Old Whittington STF

I need to ask you for some missing information before I can do any more work on your application. Please provide us with more information identified in the questions below.

15) Site Condition report You have provided a site condition report in line with H5 guidance, however we cannot identify where extra land has been included within your permit boundary. As such we do not believe that this is required and would not look to assess this as part of your application.

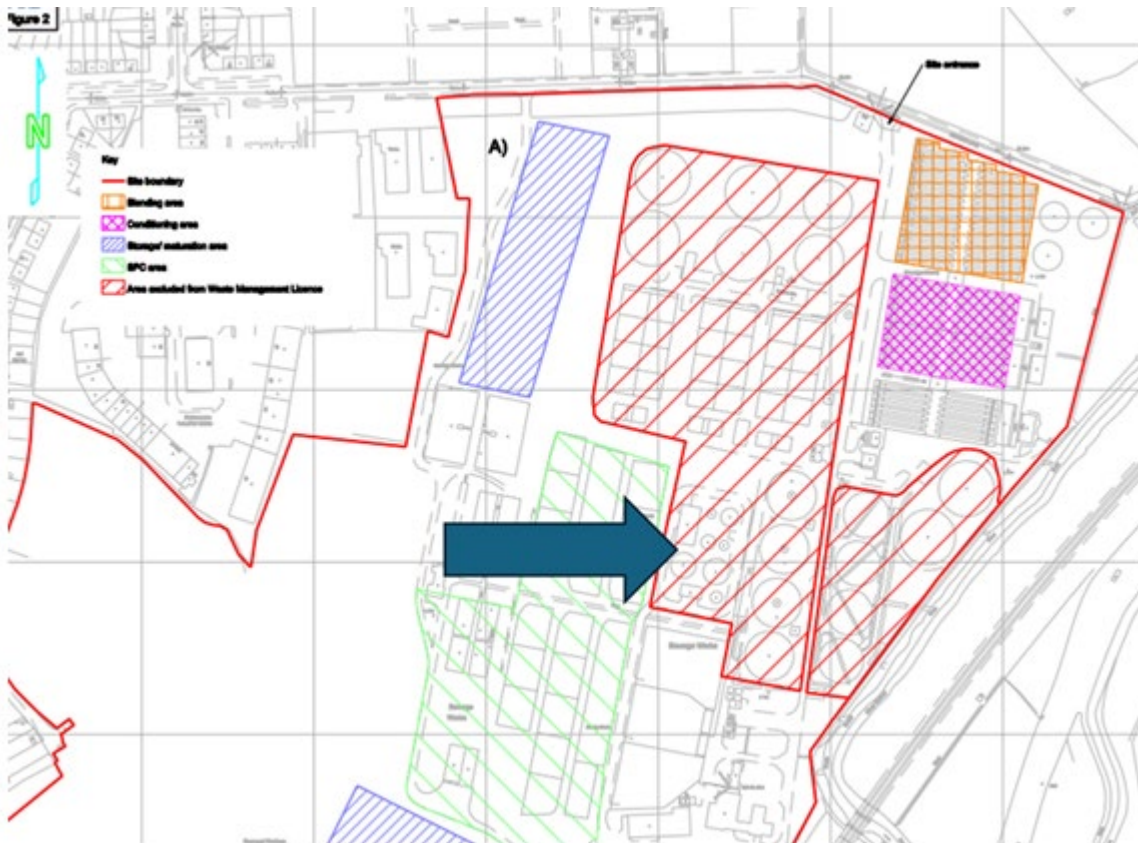
Confirm that you are not including extra land within your existing permit boundary.

Form C2 has been amended (Q5b). Extra land is required in the existing permit boundary and therefore the SCR is required.

It's YW's understanding that the conditioning permit, which is being varied through this IED application process, included an area of etched out land that was the STW. Some of this STW land has now become the STF. This is roughly at the location given on this figure.
